PROJECT NAME: CHARLOTTE  
PROJECT NUMBER: BO 1445(36)

FILE NAME: sl4j235typ.dgn  
PROJECT LEADER: M. SARGENT  
DESIGNED BY: J. WEAVER  
TYPICAL SECTIONS

PROPOSED TRUSS TYPICAL SECTION

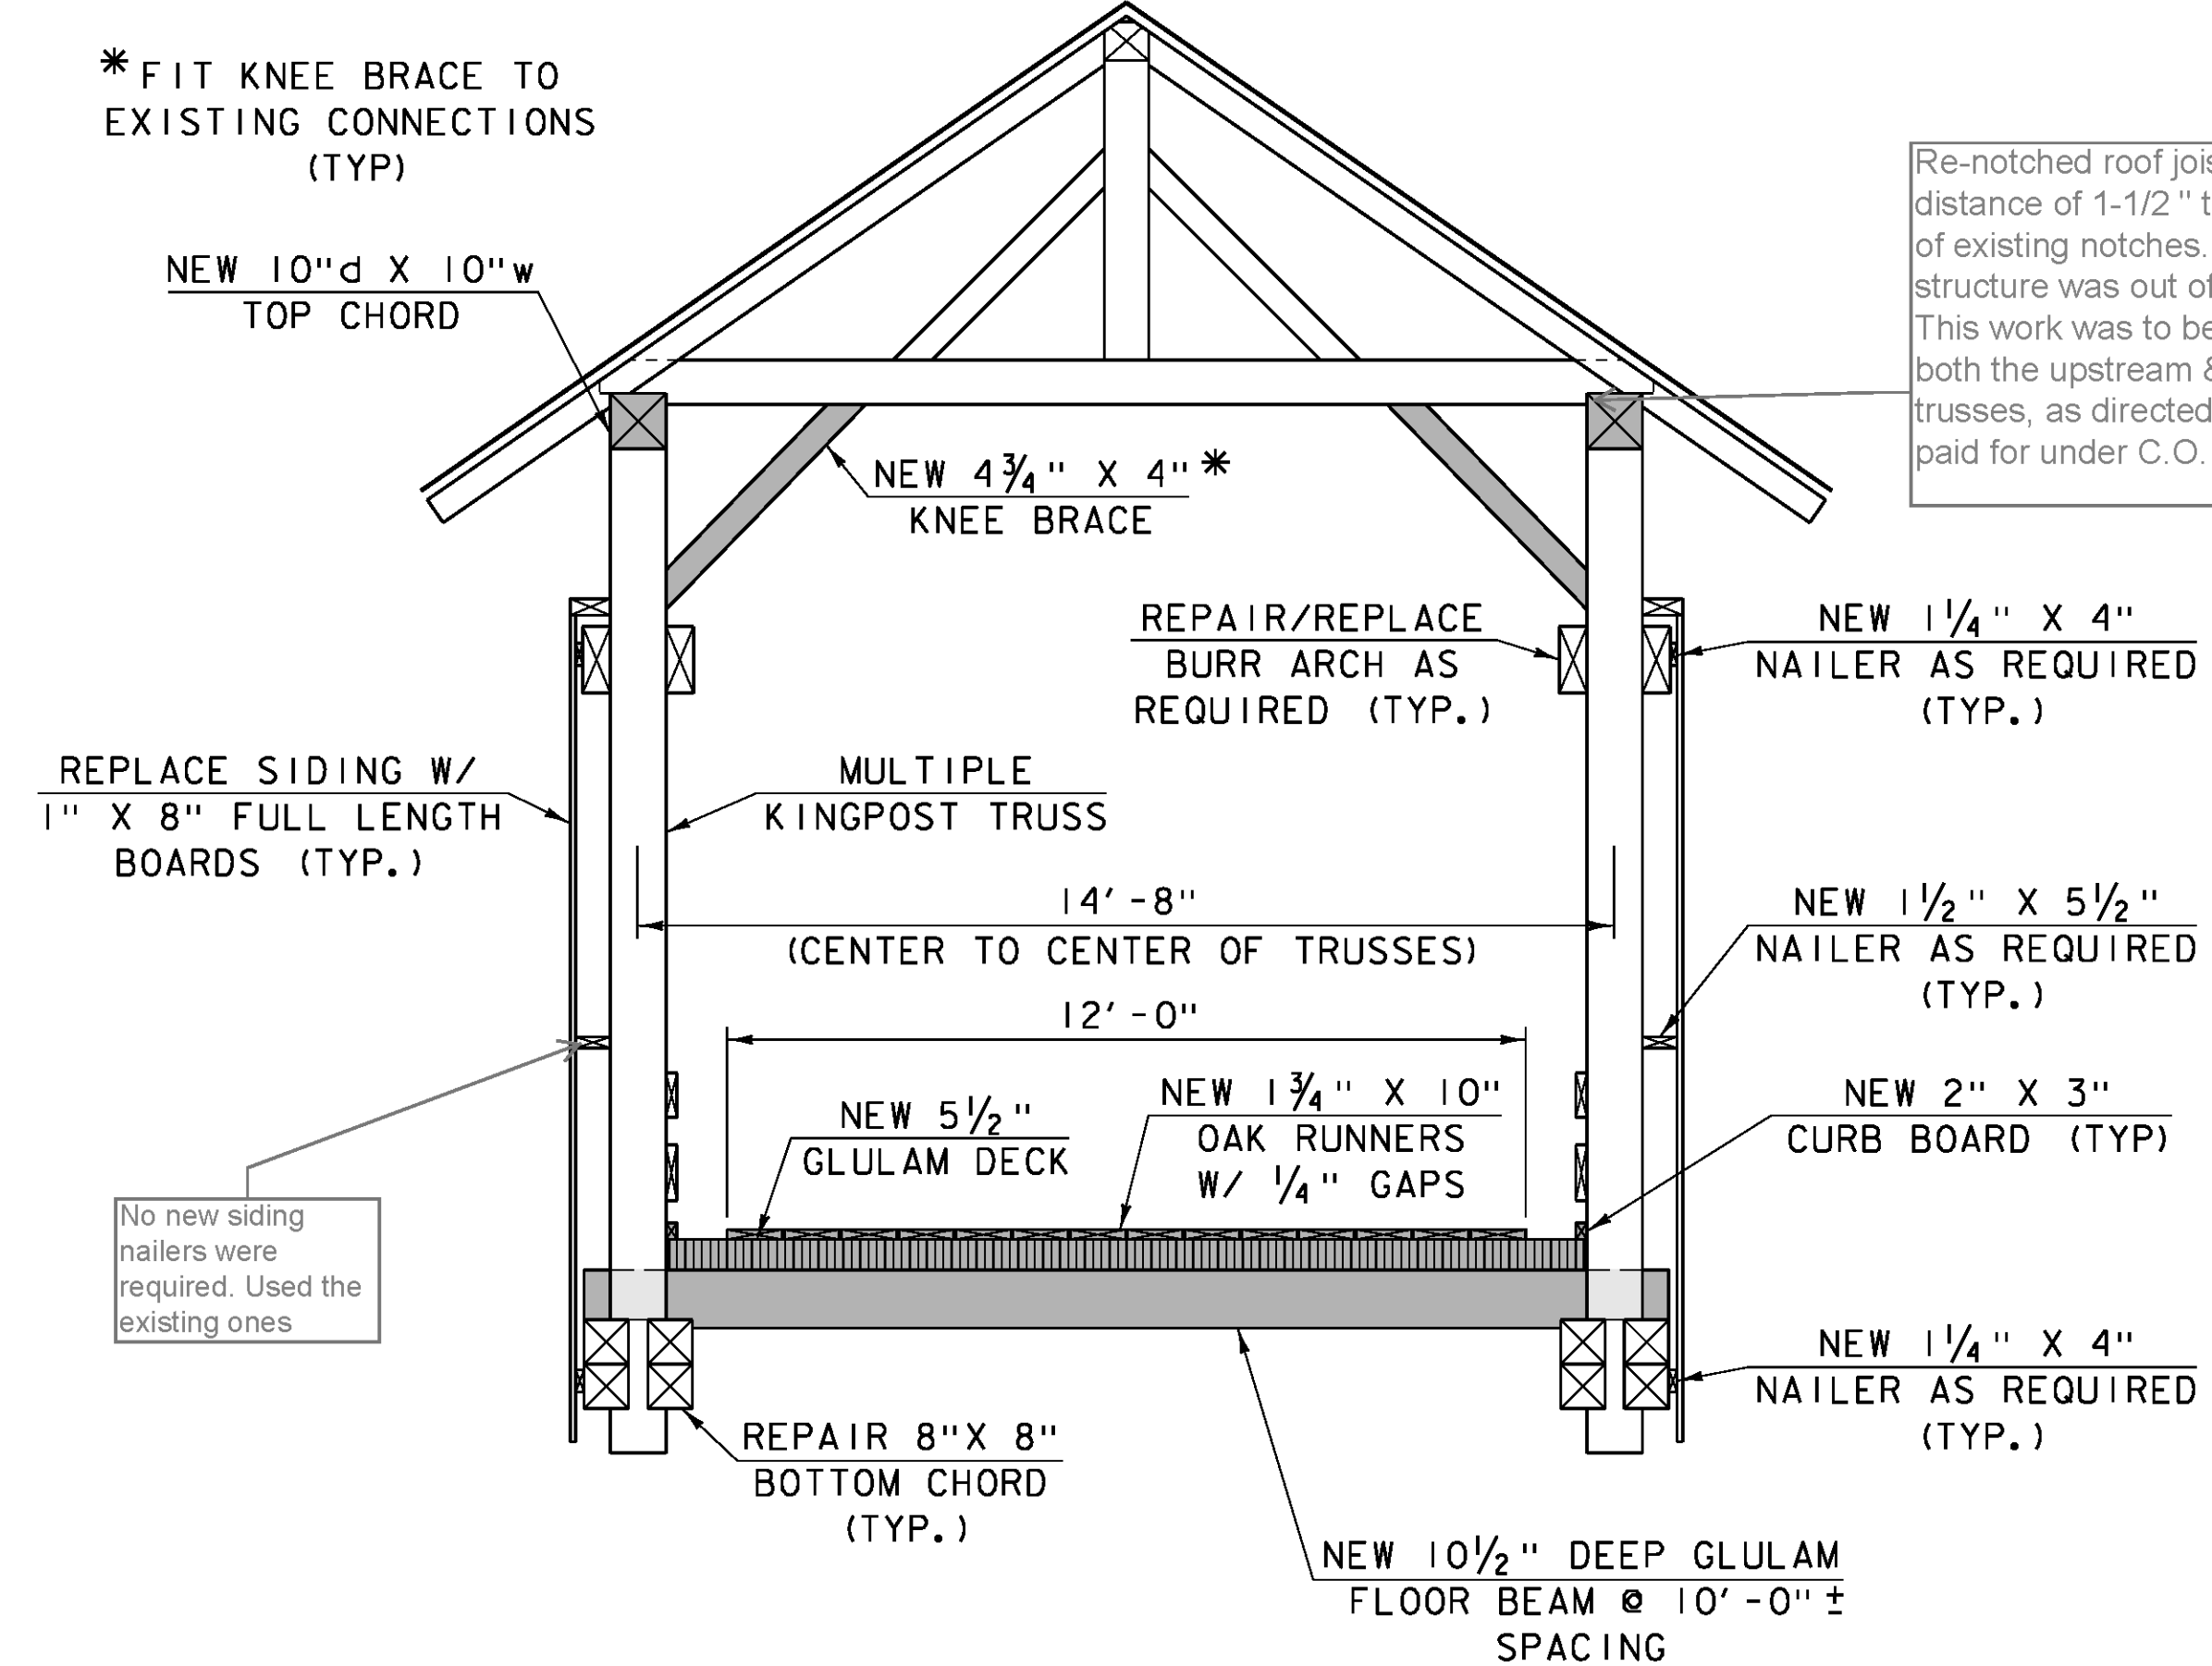
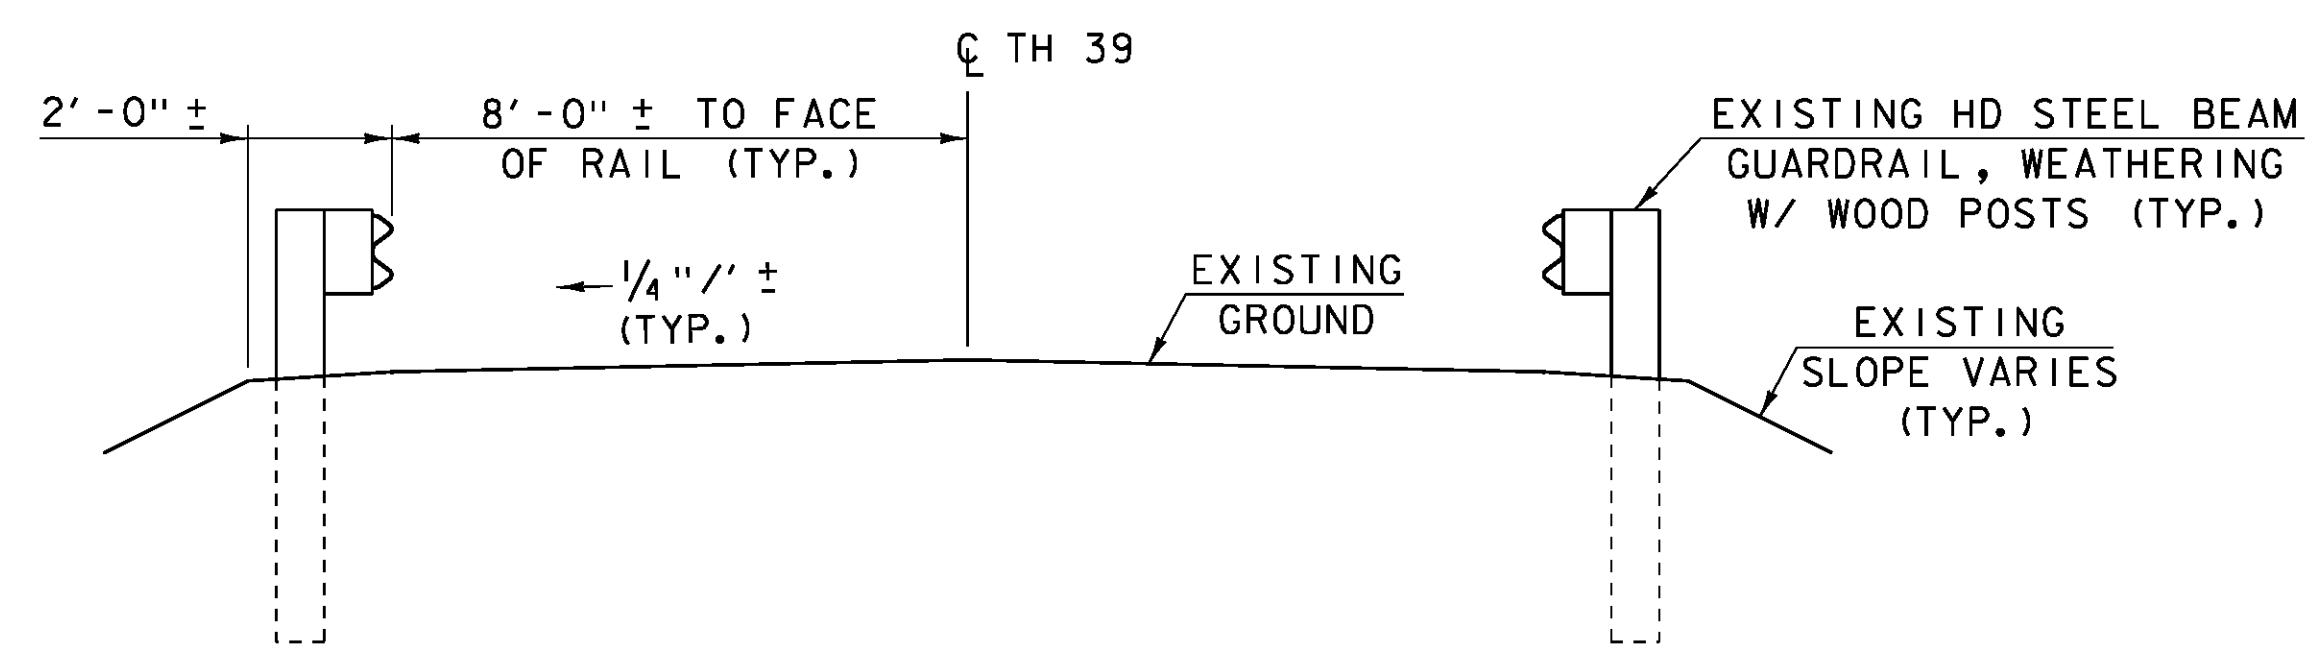
Re-notched roof joists to a distance of 1-1/2" to the outside of existing notches. Existing structure was out of plumb by 4". This work was to be performed at both the upstream & downstream trusses, as directed by W.O.# 6 & paid for under C.O. # 004.

No new siding nailers were required. Used the existing ones

GUARDRAIL SCHEMATIC PLAN  
NOT TO SCALE

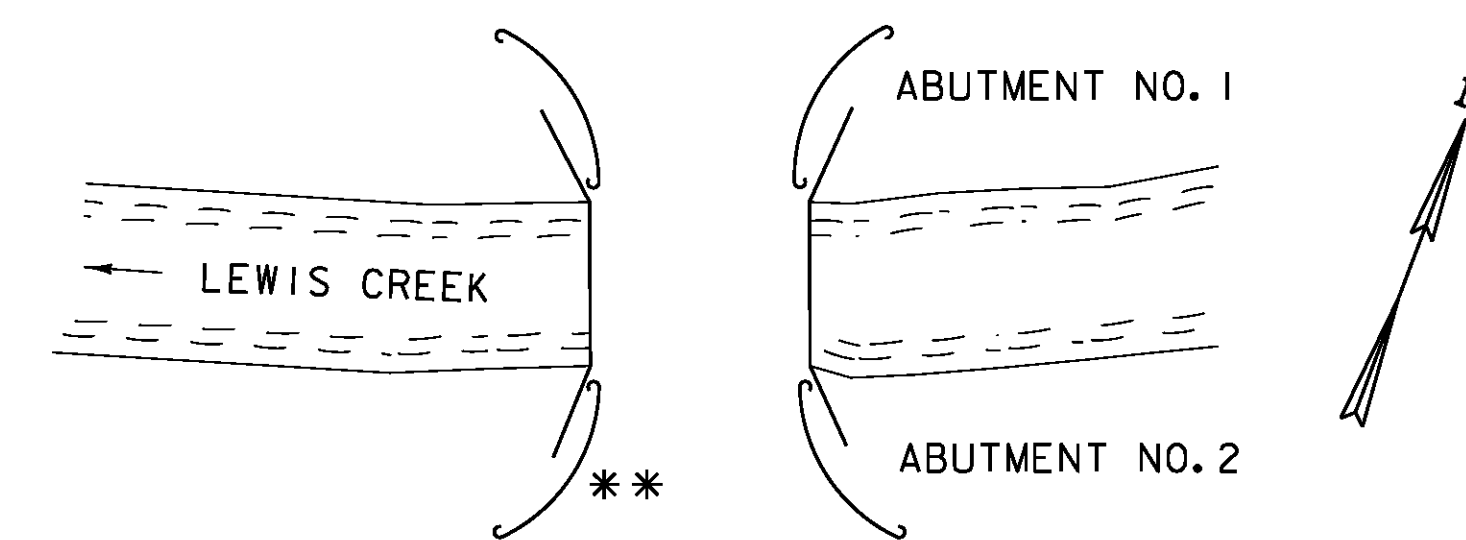
Guardrail was in poor condition. All of the rail on the North side of the bridge was replaced with new steel beam rail, weathered. All of the rail on the South side of the bridge was removed and reset.
